H-11238

DESCRIPTIVE REPORT

General Locality Kasaan Bay

Sublocality Skowl Arm

The junction locations of H11238, H11236, H11239, H11240

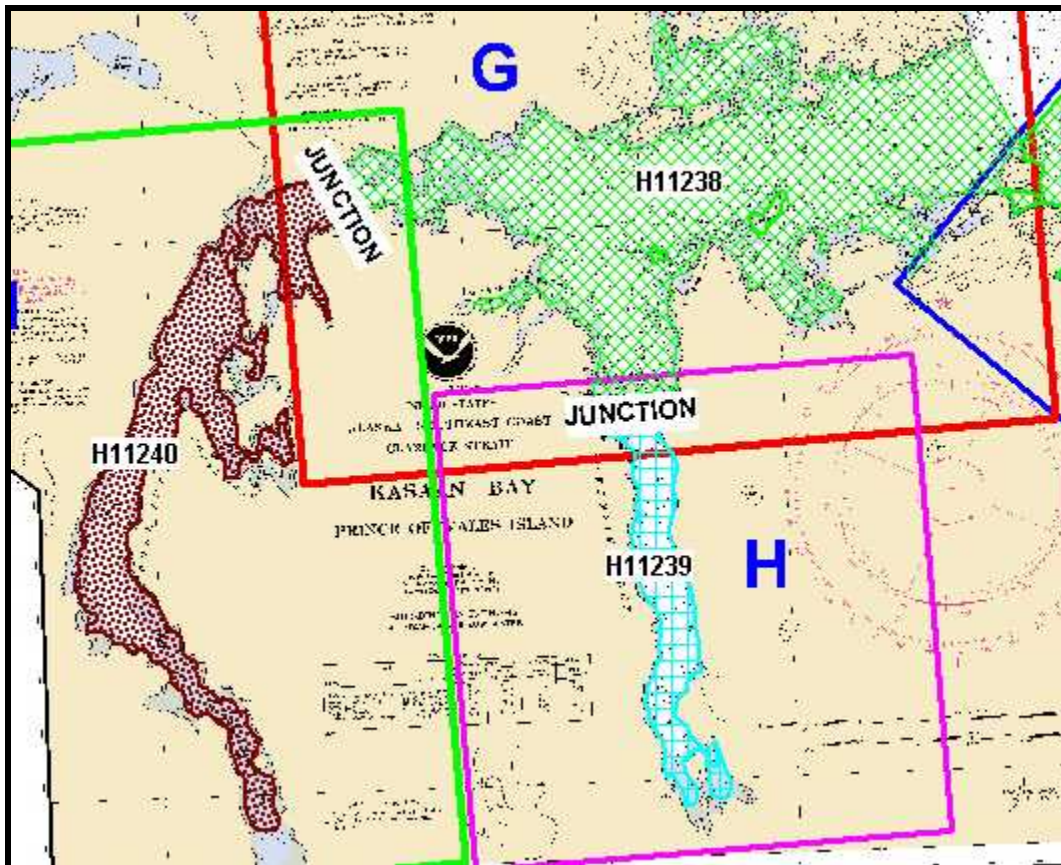
The easterly, westerly and southerly limits of this survey junction with H11236, H11240 and H1129⁶, respectively (2003, Scale 1:10,000). All of the smooth sheets were plotted at the same scale and the soundings at all survey junctions agreed well.⁷ There are no recommendations and no adjustments were made.

⁶ Strikethrough ~~1129~~, replace with “11239”.

⁷ Concur. In PHB processing, H11238 was also compared with OPR-0331-KR-02 survey H11098. In general, junction areas showed very good correlation. An exception occurred in the area of Kasaan Point, where there was a discrepancy between smooth sheet MHWL and ledges shown for H11098 and H11238. The H11098 shoreline was shifted seaward of the charted shoreline in the area between approximately Lat 55/26/29N, Lon 132/17/32W and Lat 55/26/35N, Lon 132/16/56W. Use verified shoreline from H11238 in this area, with some ledgelines from H11098, as depicted on the Hdrawings.

Note that errors occurred in the depiction of contours on the smooth sheet. Contour errors have been corrected on the Hdrawing.

Smooth sheet H-11238 overlaid on Chart 17426 for comparison

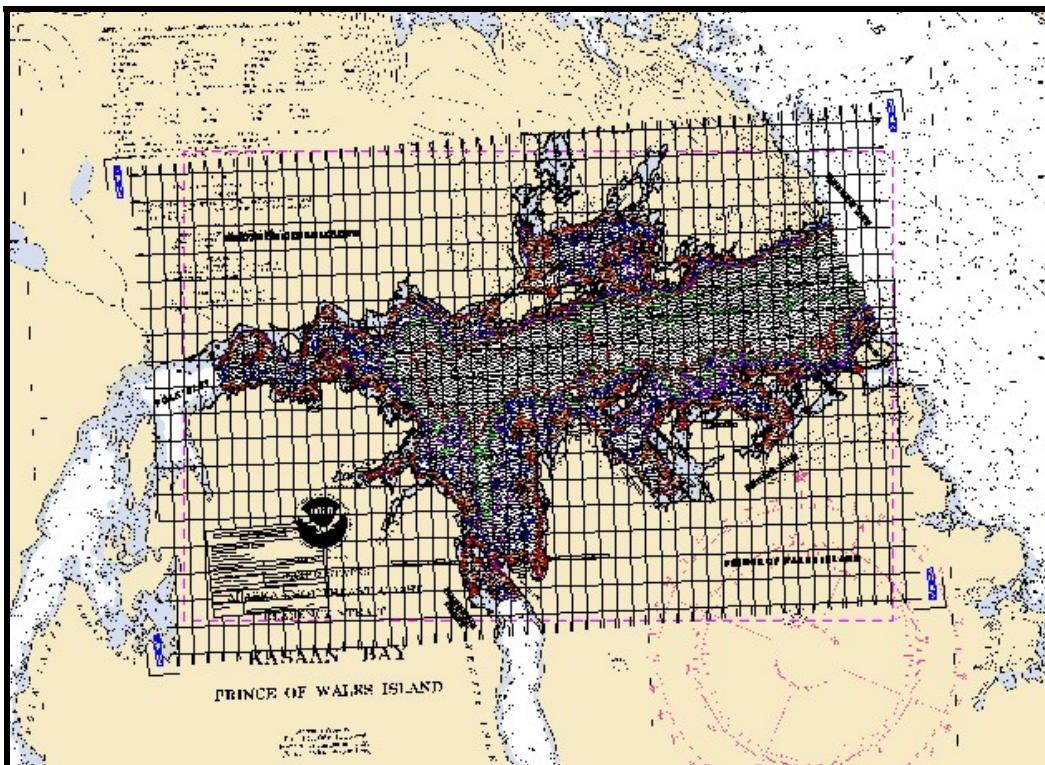
This survey generally agreed well with the charts.¹⁵ Occasionally, minor disagreements with the curves or soundings were noted. Charted and remote sensing features that differed significantly are discussed on the following pages. Refer to “Section D2 Additional Results” for shoreline investigation results affecting this chart.

¹⁵ Concur.

New Rocks found from bathymetry(circled red) in Chart 17426

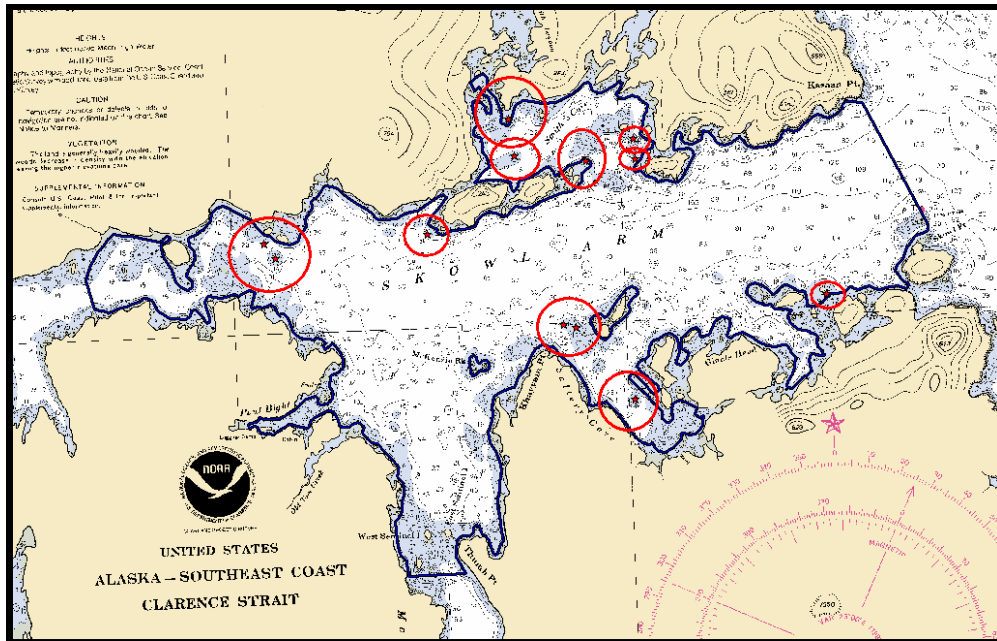
There are seventeen new rocks identified in this survey from bathymetry. The following is a list of their positions and depths.¹⁶

Based on the results of survey H-11238, the Hydrographer recommends updating the next editions with the rocks listed.²⁸

¹⁶ Chart all features according to the smooth sheet and Hdrawing except as noted.

²⁸ Concur with clarification. Chart rocks according to the smooth sheet and Hdrawing as noted.

Vessel anchorage symbol near East Sentinel Island , Chart 17426

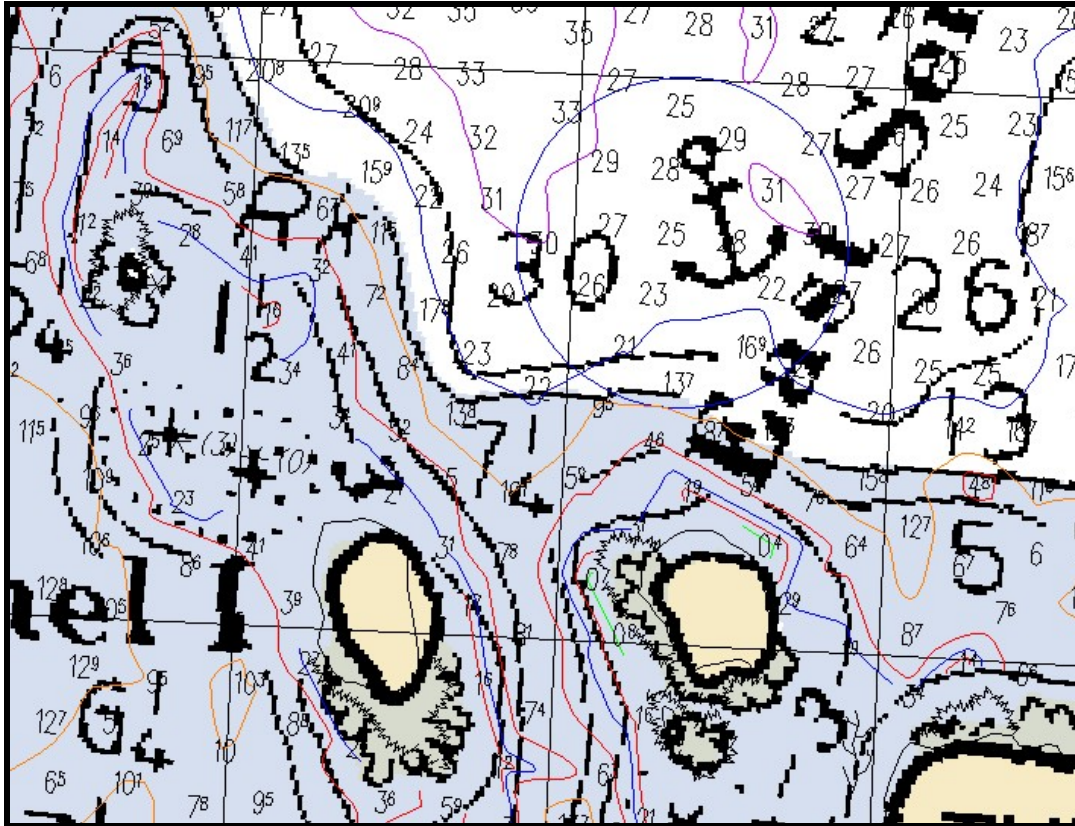
Chart 17426 has one vessel anchorage symbol. All the soundings agree well with the chart in this area. The hydrographer recommends the symbol be retained as charted.²⁹

²⁹ Concur.

Skowl Point Light (22380)

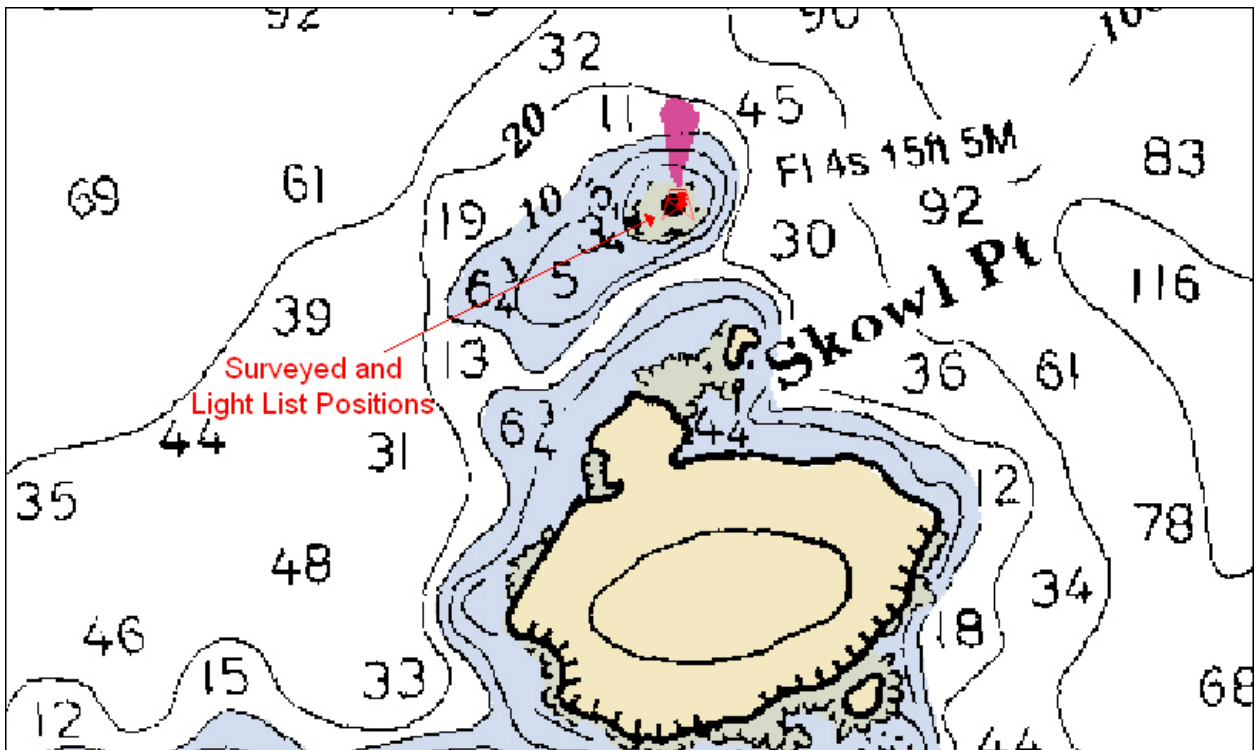
There is one aid to navigation to report in survey H-11238, Skowl Point Light. This navigation aid appears to serve its intended purpose and was located within an acceptable range of the charted position and the 2003 Light List vol. VI, recorded position.⁴⁸

⁴⁸ Concur with clarification. Position aids to navigation according to the most recent ATOINOS information.

AWOIS item 52787 search area, looking west

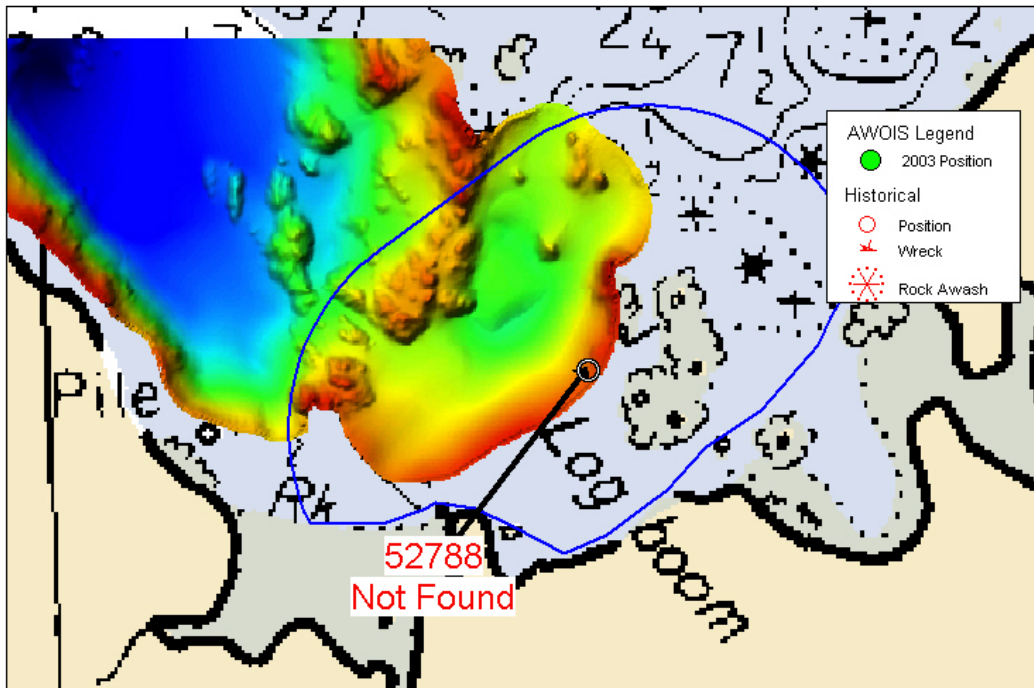
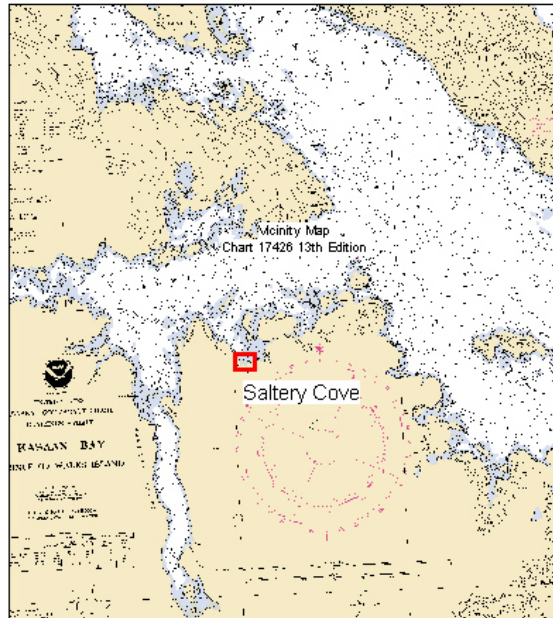
Based on the results of survey H-11238, the hydrographer recommends removing the logging camp symbol and notation from the chart and database.⁴⁹

⁴⁹ Concur. See AWOIS report 52787, attached to this report.

AWOIS item 52788, radius, 2003 bathymetry, Chart 17426

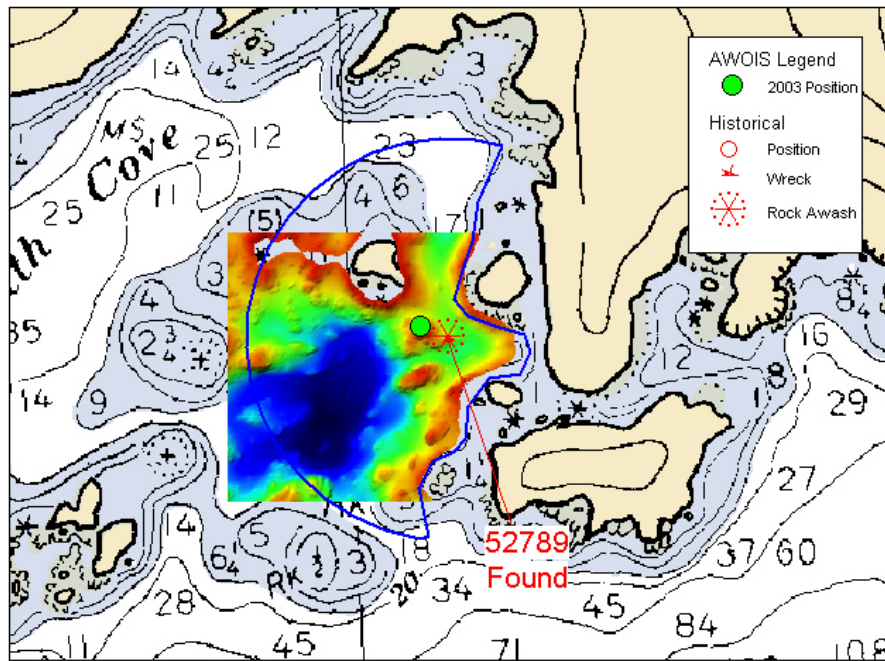
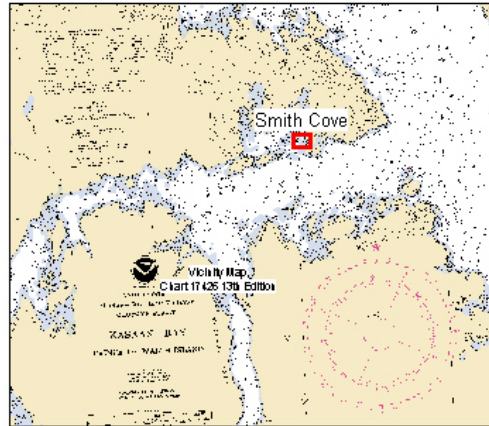
Based on the results of survey H-11238, the hydrographer recommends the log boom notation be removed from the chart and database.⁵⁰

⁵⁰ Concur. See AWOIS report 52788, attached to this report.

AWOIS item 52789, radius, 2003 bathymetry, Chart 17426

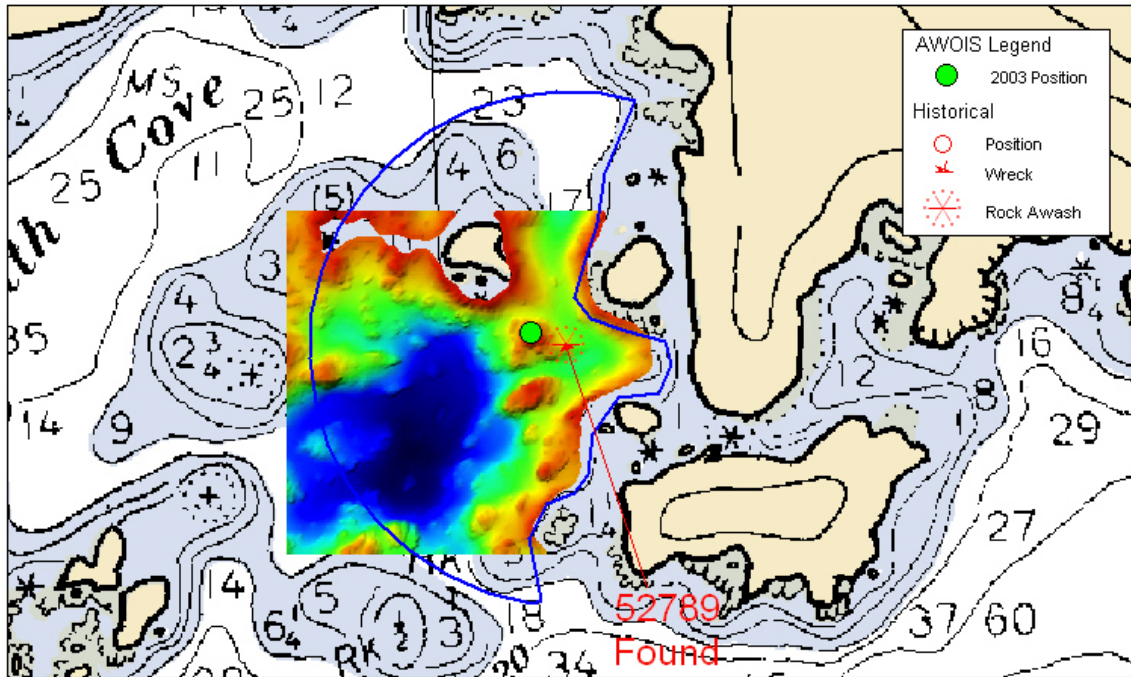
Based on the results of survey H-11238, the hydrographer recommends that the rock symbol be moved to the surveyed position and updated in the database.⁵²

⁵² Concur with clarification. See AWOIS report 52789, attached to this report.
